Finn Valley Wind Action Group

Ref: SU05E.319466

Development Description

Substitute Consent application for 25 no. deviations from the permitted Meenbog Windfarm development (granted under ABP PA05E.300460).

VISUAL IMPACT

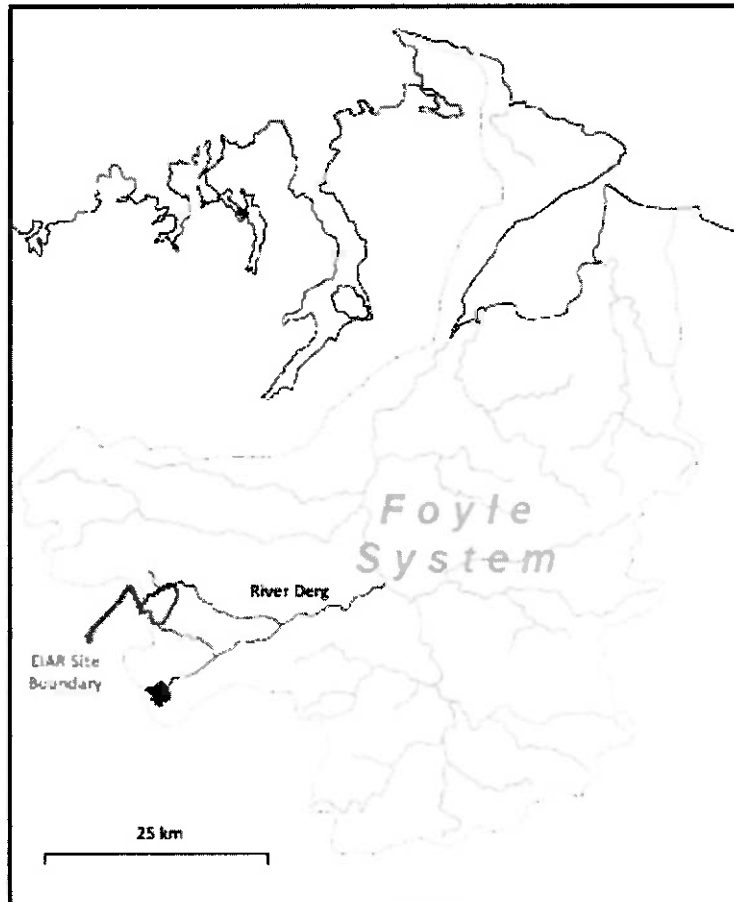
A principal concern of this proposal is the visual impact and the anomalous position of the windfarm in a landscape virtually surrounded and bordered by designated/protected areas such as SACs, NHAs and ASSIs (N.Ireland). The turbines are 156.5 m high on a slope having a relief of approximately 225m between N15 road level and the top of the ridge. In short, the turbines (as in the original proposal) are some 70% of the maximum relief in the landscape of the site. By any measure, these turbines will represent a significant visual intrusion, only mitigated slightly by the relatively small scale of the trees in the forestry which covers much of the site. The proposed turbines are significantly larger than most of those in the nearest windfarm development and in many cases, 50% taller. The included maps of visual impact in the EIA Report clearly demonstrate the wide impact of the scale of this windfarm development although the impact is often described as 'moderate' in the report, and not just along the N15.

The impact on a scenic landscape of 19 large turbines and the need to conserve such a landscape is the subject of the EU Landscape Directive. The flat valley of the Barnesmore Gap is a scenic landscape well-recognized in Donegal as well as nationally. That the area is worthy of conservation is demonstrated by the number of designated areas (under the Habitats Directive) on both sides of the border. As shown on an EIAR drawing (no. P1249-2-1217-A3-906-00A), the site borders the Barnesmore Bog NHA, the Cashelnavenan Bog NHA, the Croaghonagh Bog SAC and pNHA as well as the River Foyle SAC & ASSI in Northern Ireland.
